Project: Engineering, Procurement and Construction of the New Administrative Capital Monorail and 6th October City Monorail (Contract 93/Metro).

Subject: Non-conformities in Shop Drawings. // 93M-BOA-NAT-LOT-33659

93M-BOA-NAT-LOT-33659

Project Code	Rubric	Initiator	Lot	Ref	Number	Revision
9 3 M	0 4 0 7	A C	C B C	1 1	A D W G	5 0 0 0 1	A

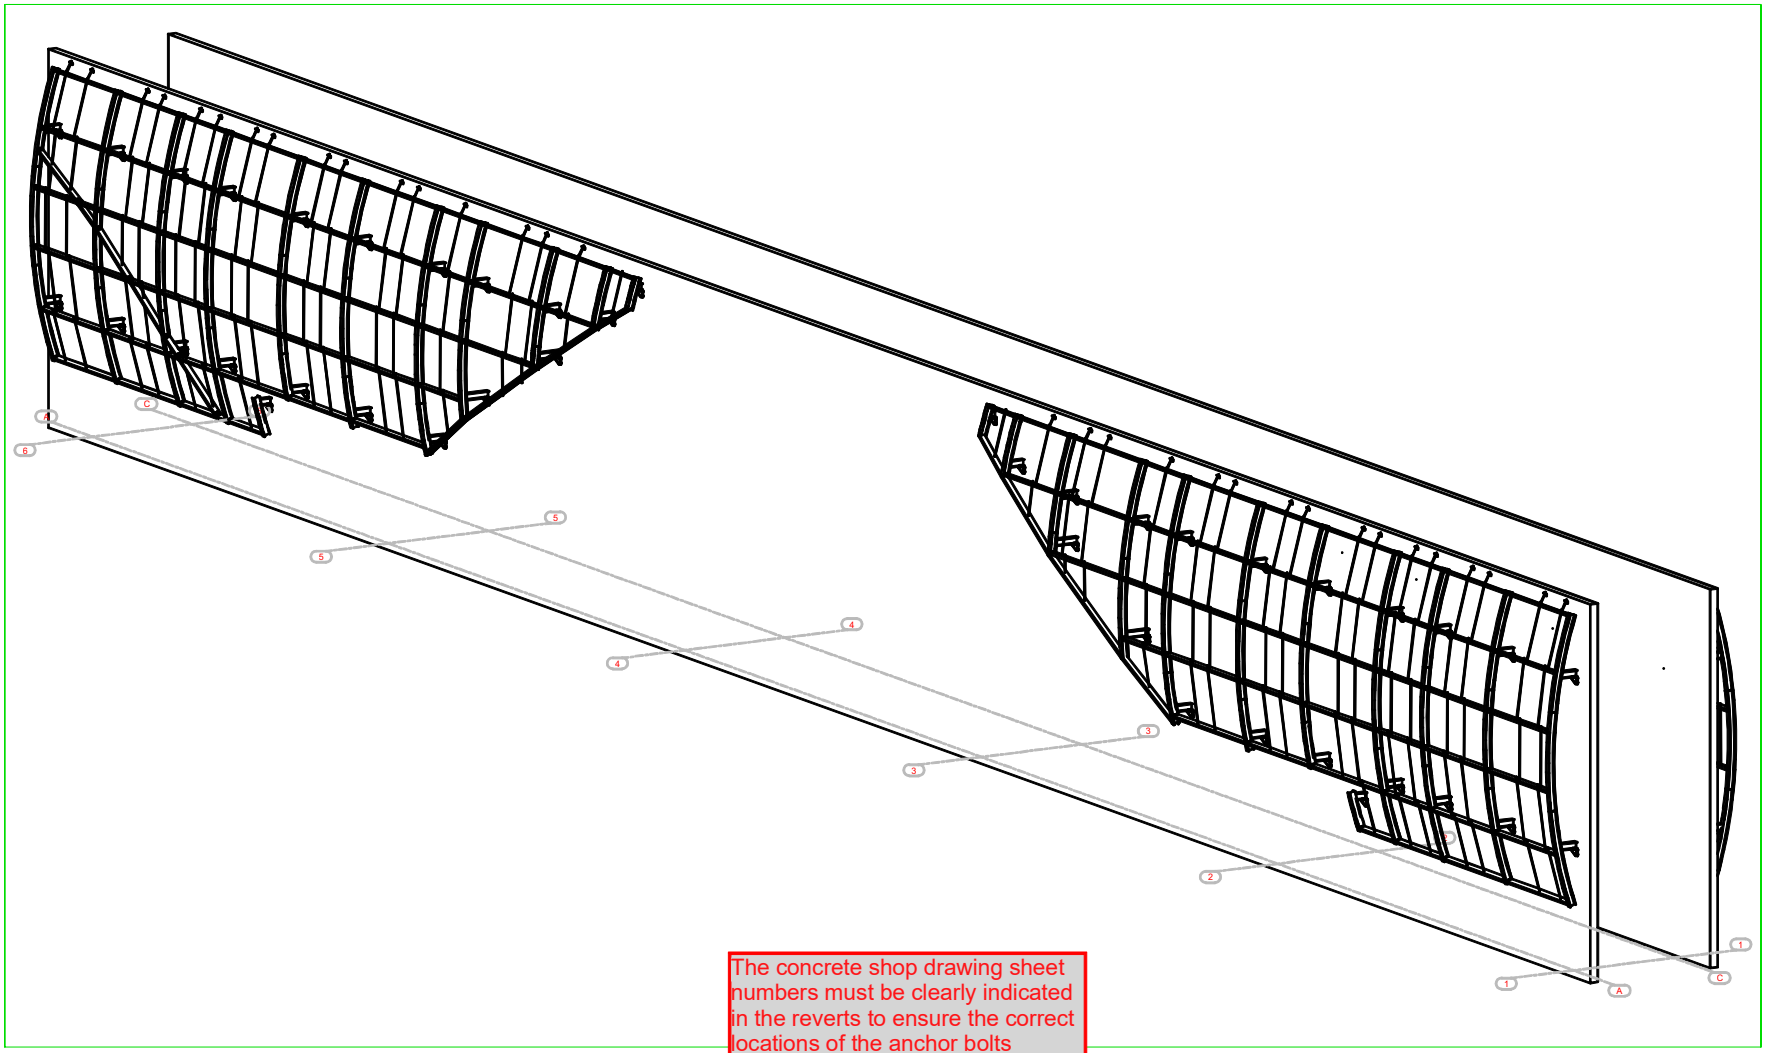
-Please submit a design reference for this detail other way please submit a verification

All connection must be clearly detailed with complete information in the erection drawing

The contractor must carry out coordination between the concrete columns and steel elements to ensure their full alignment and to verify any shift between the concrete and steel . in addition, the concrete shop drawing must be submitted in auto CAD format for review and for verifying the locations of the anchor bolts

The concrete shop drawing sheet numbers must be clearly indicated in the reverts to ensure the correct locations of the anchor bolts

Detail E

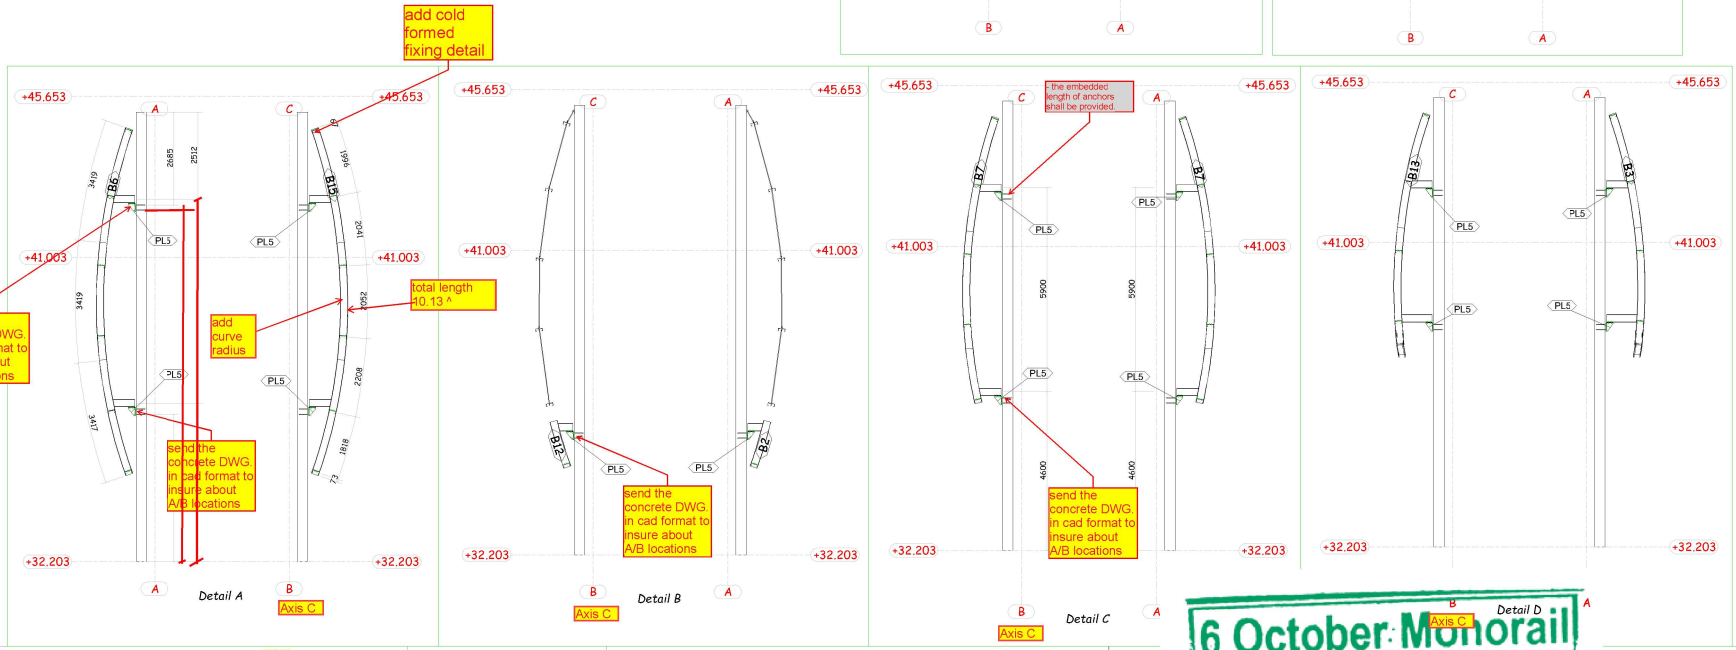
+45.653
+41.003
+32.203
add details for c section connection
add detail for A/B connections with embedded length
add curved radius and curved redial angle
levels are not matching
Grid A

-The connections details must be included in the erection drawing

add cold formed fixing detail
send the concrete DWG. in cad format to insure about A/B locations
add curve radius
total length 40.13 ^
send the concrete DWG. in cad format to insure about A/B locations
send the concrete DWG. in cad format to insure about A/B locations
- the embedded length of anchors shall be provided.
send the concrete DWG. in cad format to insure about A/B locations
+45.653
+41.003
+32.203
PL5
Axis C
Detail A
Detail B
Detail C
Detail D

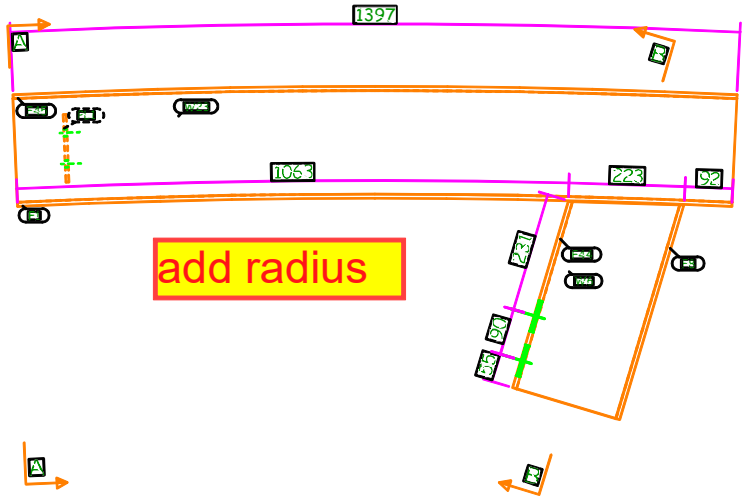
-Drawing shall be update according to the comments on the GA drawing.
-Approval is subject to approval of coordination package between multi-discipline

2 Nos. FLANGE REQUIRED AS DRAWN MARKED B3

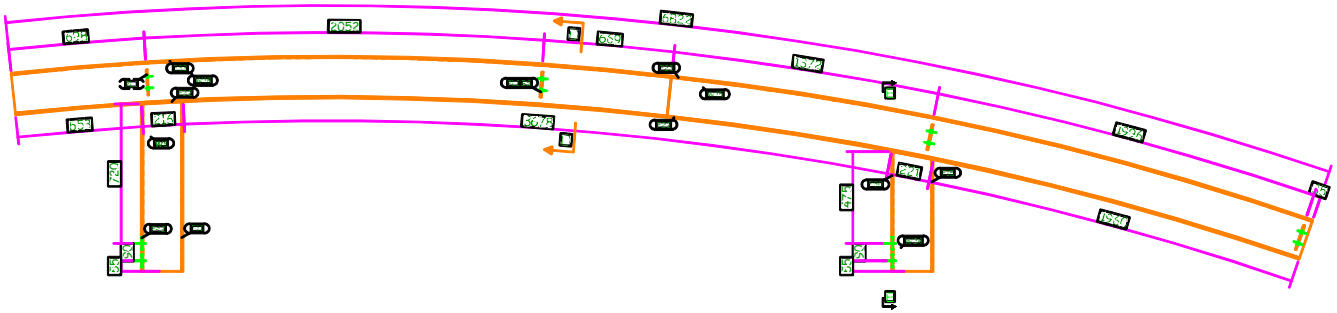
same comment as
39M-0407-ACC-6O11A-DWG-50023-A

-Drawing shall be update according to the comments on the GA drawing.
-Approval is subject to approval of coordination package between multi-discipline

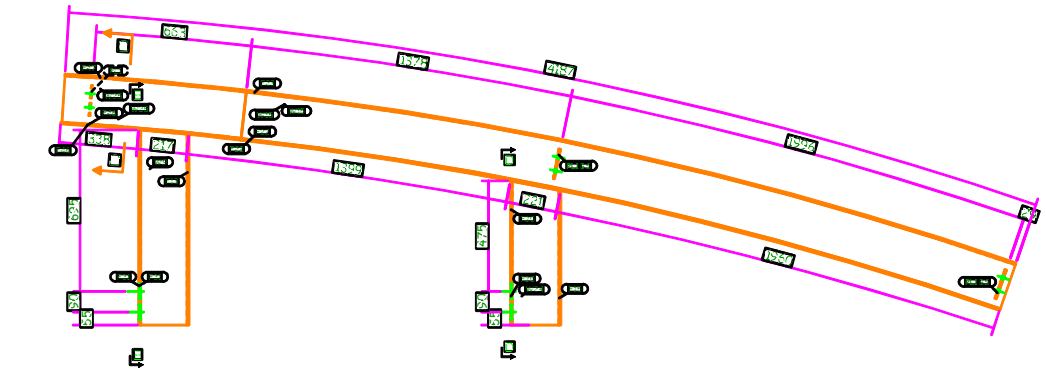
same comment as
39M-0407-ACC-6O11A-DWG-50023-A

-Drawing shall be update according to the comments on the GA drawing.
-Approval is subject to approval of coordination package between multi-discipline

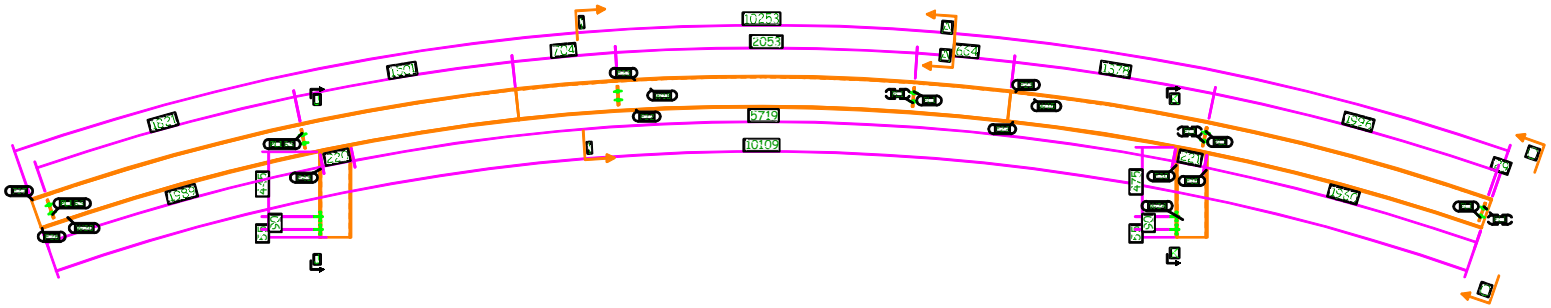
same comment as 39M-0407-ACC-6O11A-DWG-50023-A

-Drawing shall be update according to the comments on the GA drawing.
-Approval is subject to approval of coordination package between multi-discipline

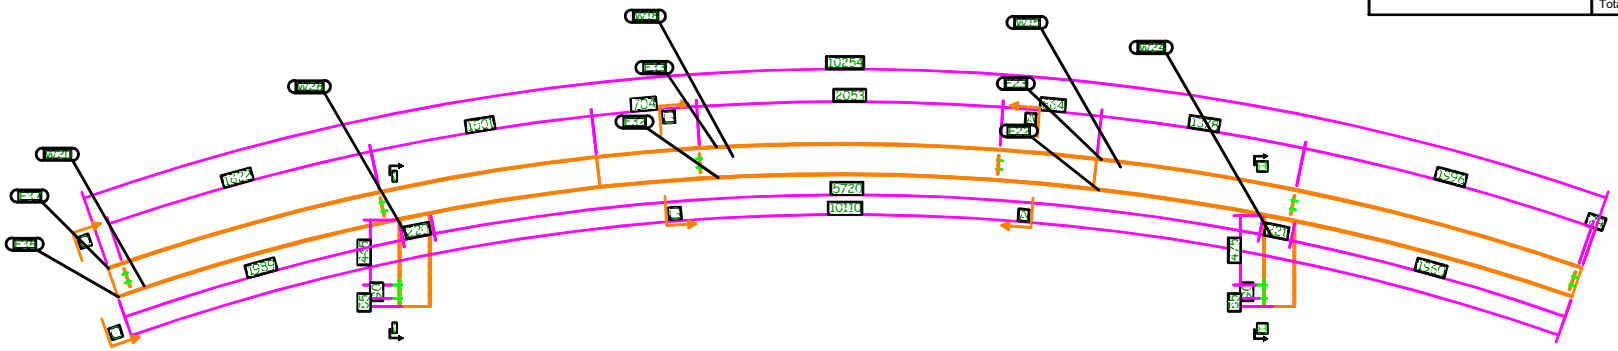
same comment as 39M-0407-ACC-6O11A-DWG-50023-A

-Drawing shall be update according to the comments on the GA drawing.
-Approval is subject to approval of coordination package between multi-discipline

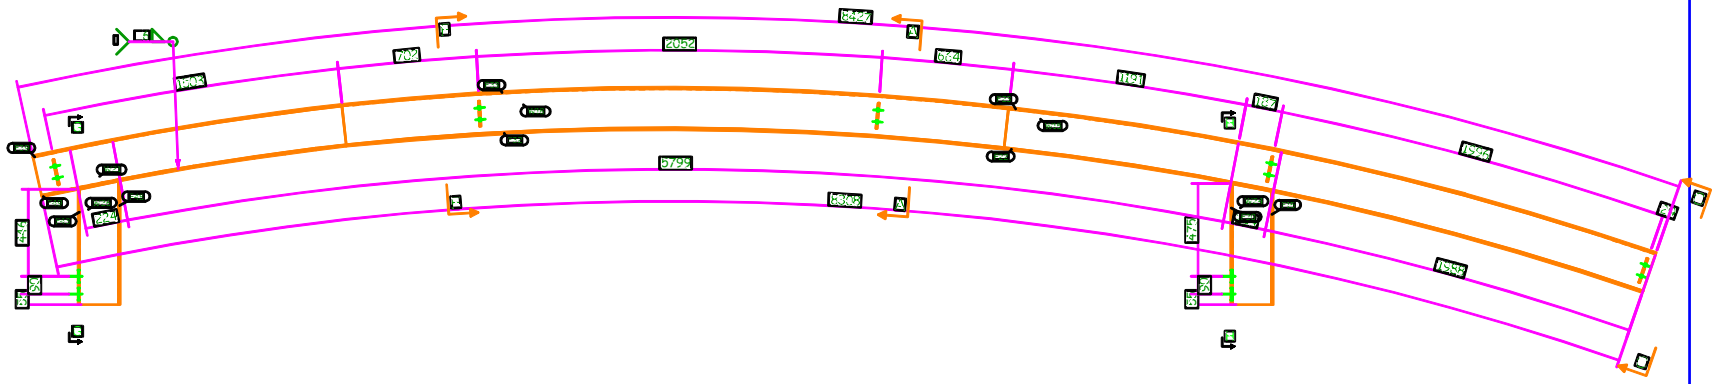
same comment as 39M-0407-ACC-6O11A-DWG-50023-A

-Drawing shall be update according to the comments on the GA drawing.
-Approval is subject to approval of coordination package between multi-discipline

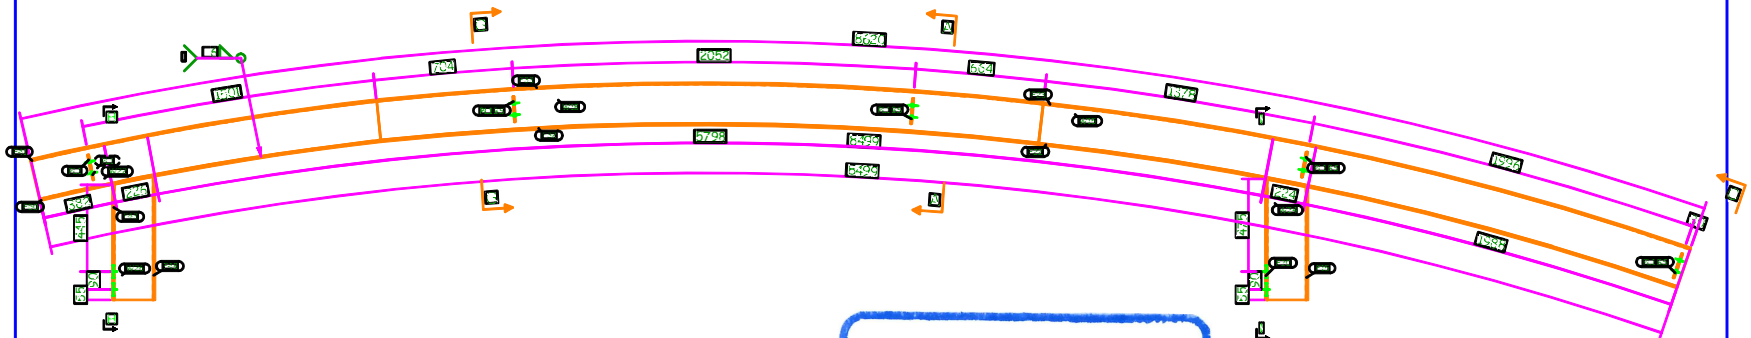
same comment as
39M-0407-ACC-6O11A-DWG-50023-A

-Drawing shall be update according to the comments on the GA drawing.
-Approval is subject to approval of coordination package between multi-discipline

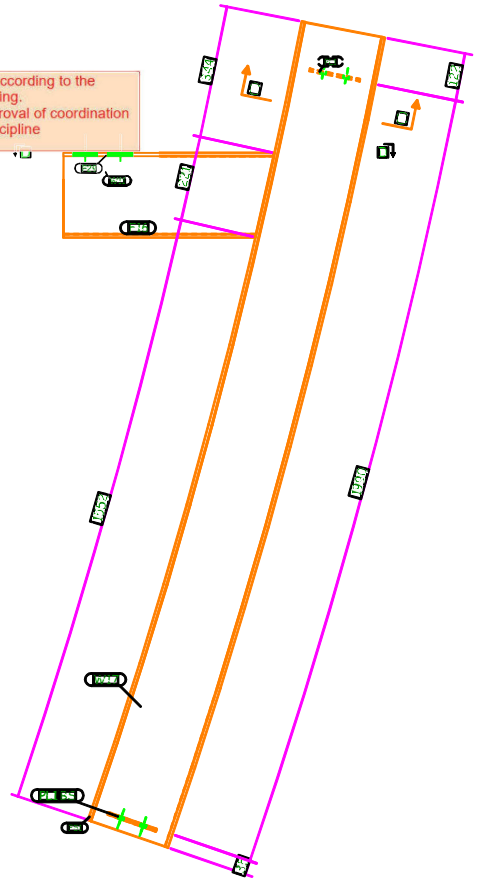
-Drawing shall be update according to the comments on the GA drawing.
-Approval is subject to approval of coordination package between multi-discipline

same comment as
39M-0407-ACC-6O11A-DWG-50023-A

2 Nos. FLANGE REQUIRED AS DRAWN MARKED B11

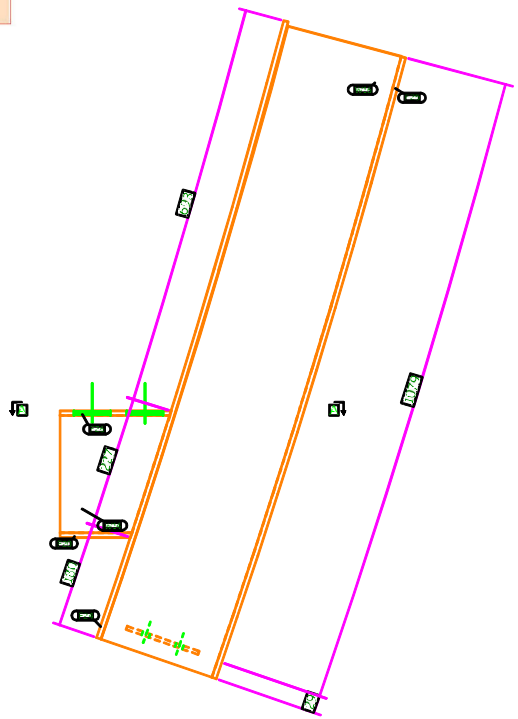
-Drawing shall be update according to the comments on the GA drawing.
-Approval is subject to approval of coordination package between multi-discipline

same comment as 39M-0407-ACC-6O11A-DWG-50023-A

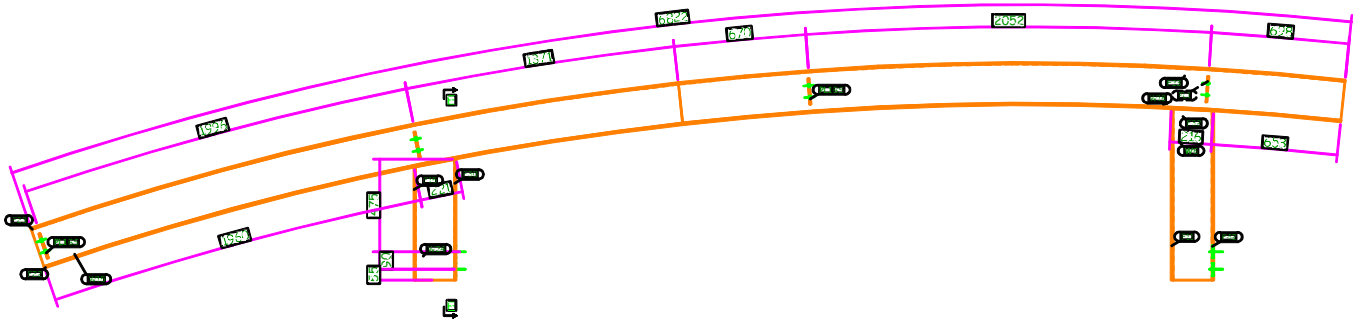
same comment as 39M-0407-ACC-6O11A-DWG-50023-A

-Drawing shall be update according to the comments on the GA drawing.
-Approval is subject to approval of coordination package between multi-discipline

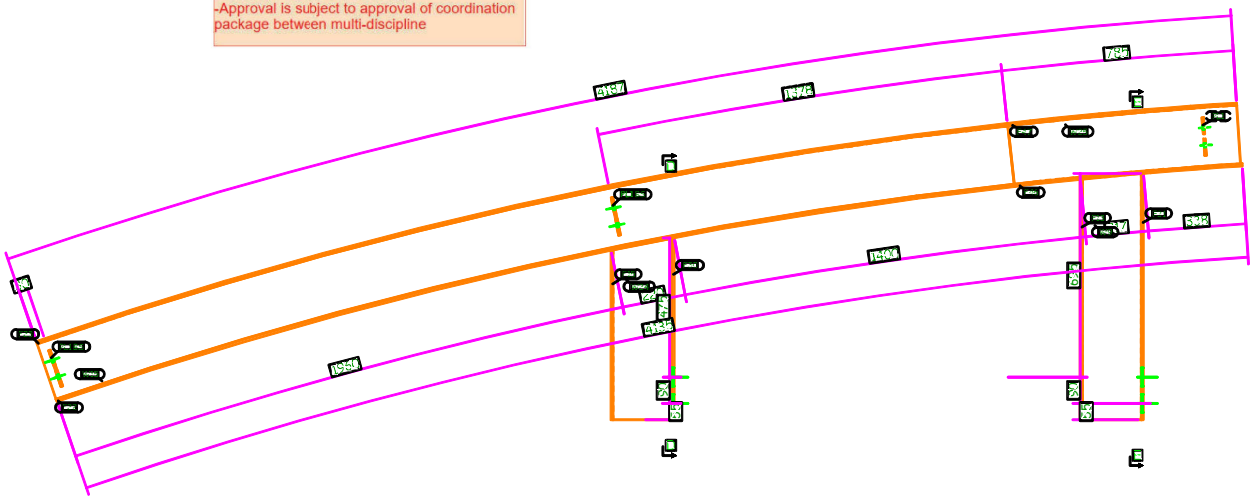
same comment as 39M-0407-ACC-6O11A-DWG-50023-A

-Drawing shall be update according to the comments on the GA drawing.
-Approval is subject to approval of coordination package between multi-discipline

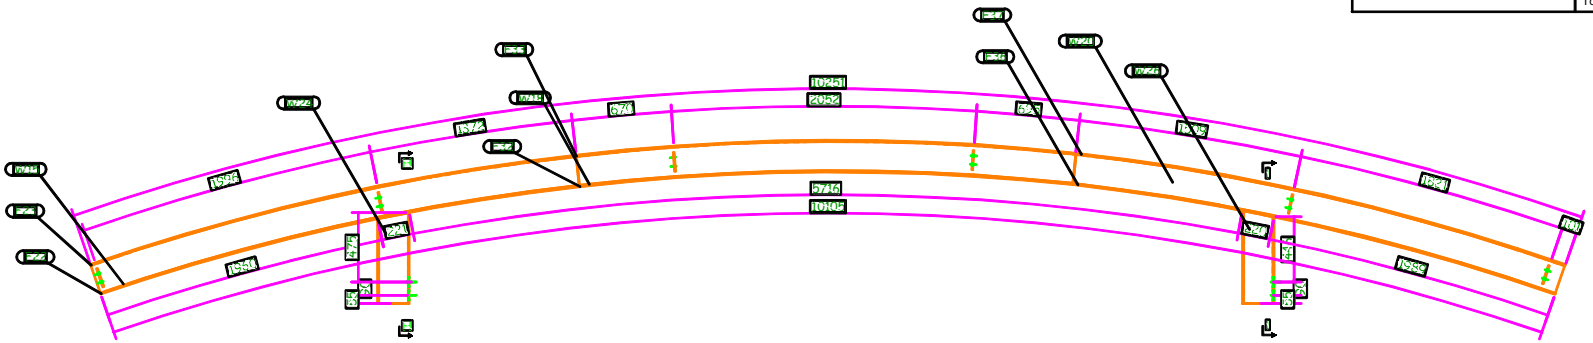
same comment as
39M-0407-ACC-6O11A-DWG-50023-A

-Drawing shall be update according to the comments on the GA drawing.
-Approval is subject to approval of coordination package between multi-discipline

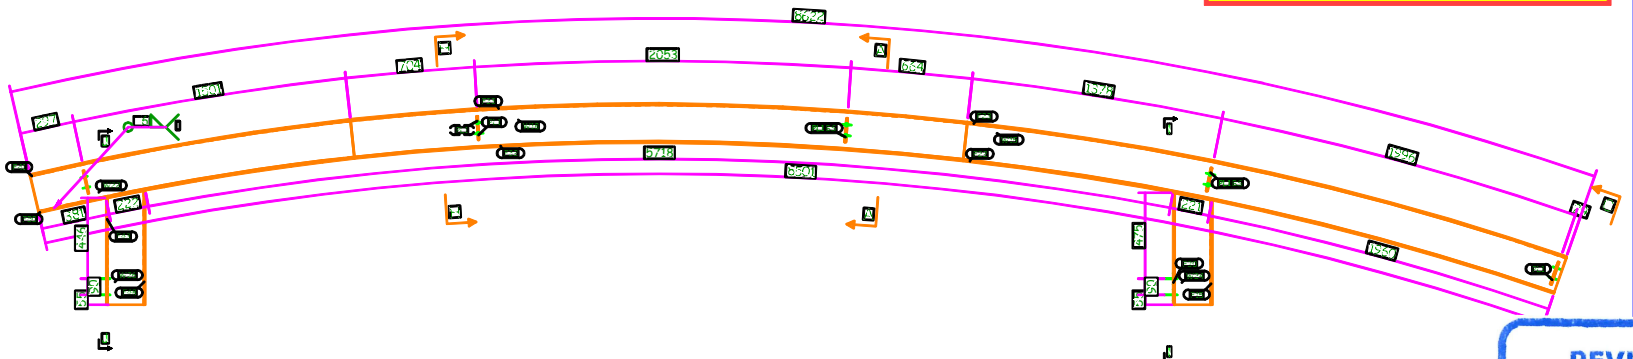
same comment as
39M-0407-ACC-6O11A-DWG-50023-A

2 Nos. FLANGE REQUIRED AS DRAWN MARKED B17

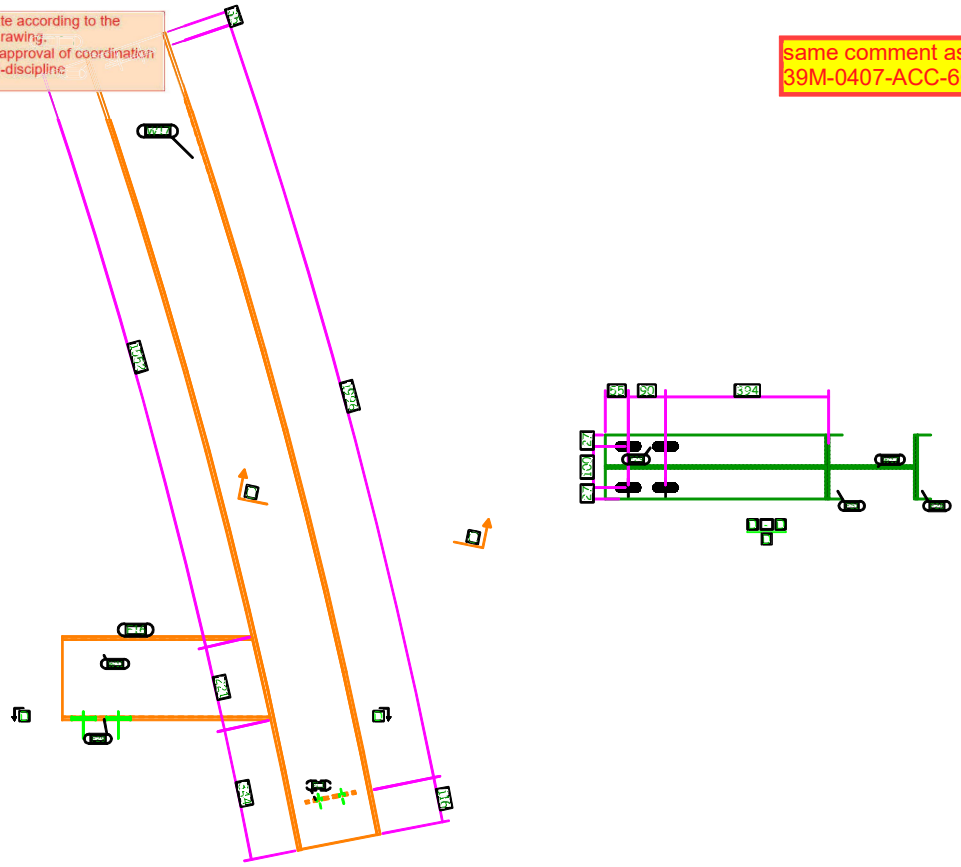
-Drawing shall be update according to the comments on the GA drawing.
-Approval is subject to approval of coordination package between multi-discipline

same comment as
39M-0407-ACC-6O11A-DWG-50023-A
